UNITED STATES PATENT AND TRADEMARK OFFICE

10/766,041

Office Action Summary

Detailed Action

FIG. 9

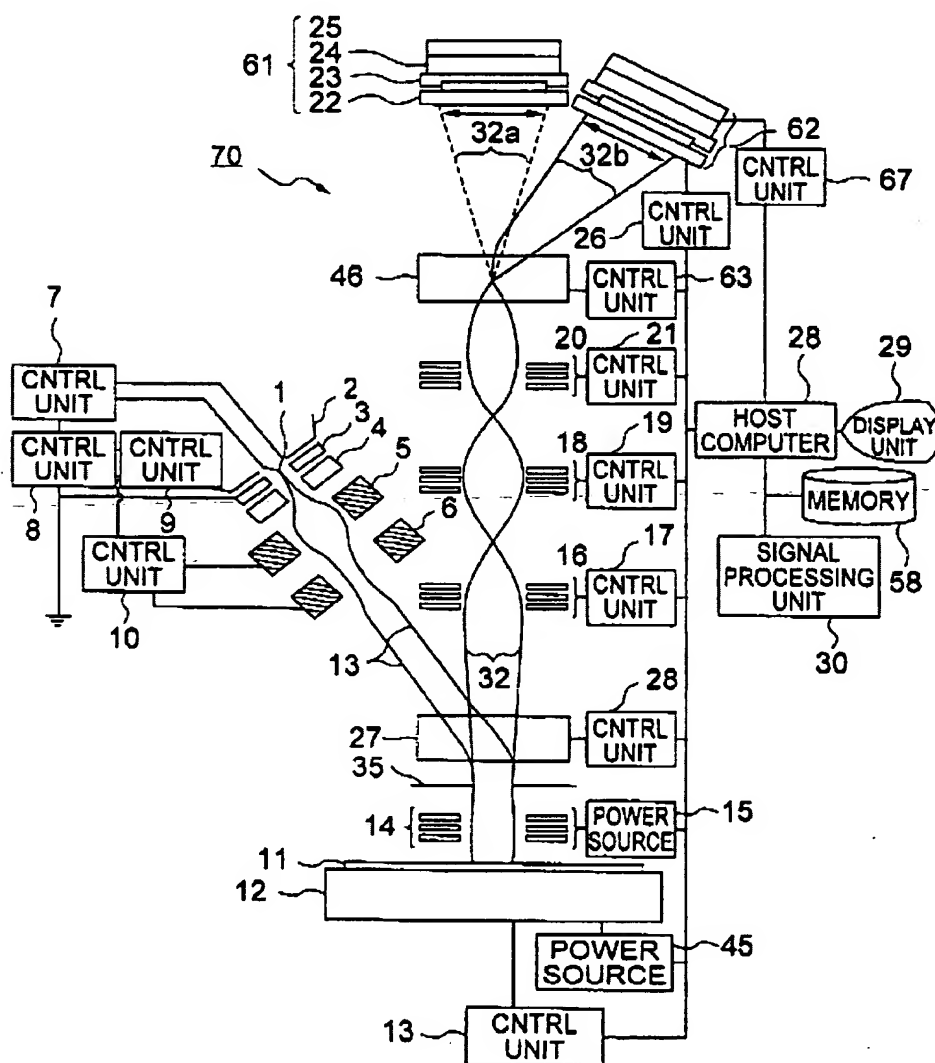
(a) An electron gun for emitting a plurality of electron beams, spaced apart at equal intervals to scan a semiconductor wafer, and a deflector 27 for deflecting secondary

electrons toward the secondary optical system, that incorporates an $E \times B$ filter above the objective lens system 14, having coils 41a and 41b, equivalent in the shape of a toroid as recited in claims 58, 59, 61, and 63. See Column 10, line 42-55; and figure 9 below;

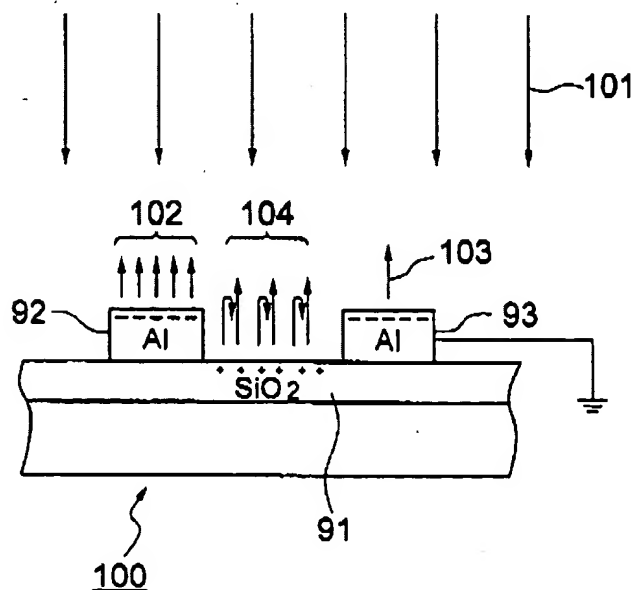
(b) Imaging with aTDICCD detector synchronized with stage movement, as recited in claim 60. See Column 7, line 56-62;
